Office Action Summary

10/674,360

ITO ET AL.

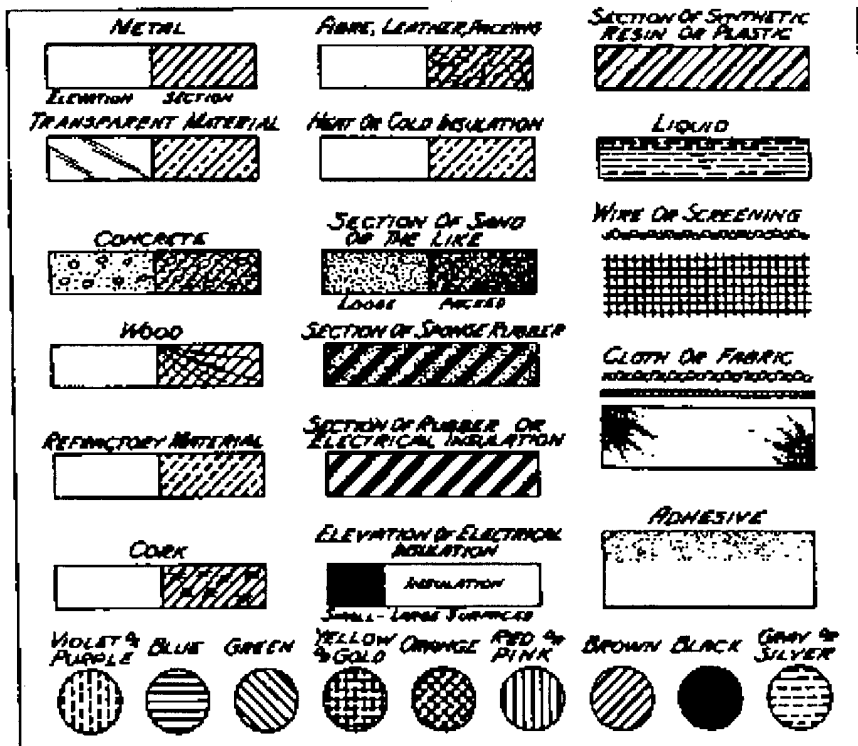
The drawings are objected to because of the following informalities:

Fig. 2: Proper cross-sectional hatching is required to properly denote insulative materials in accordance with MPEP 608.02 (see the drawing below for proper hatching examples).

Corrected drawing sheets in compliance with 37 CFR 1.121(d) are required in reply to the Office action to avoid abandonment of the application. Any amended replacement drawing sheet should include all of the figures appearing on the immediate
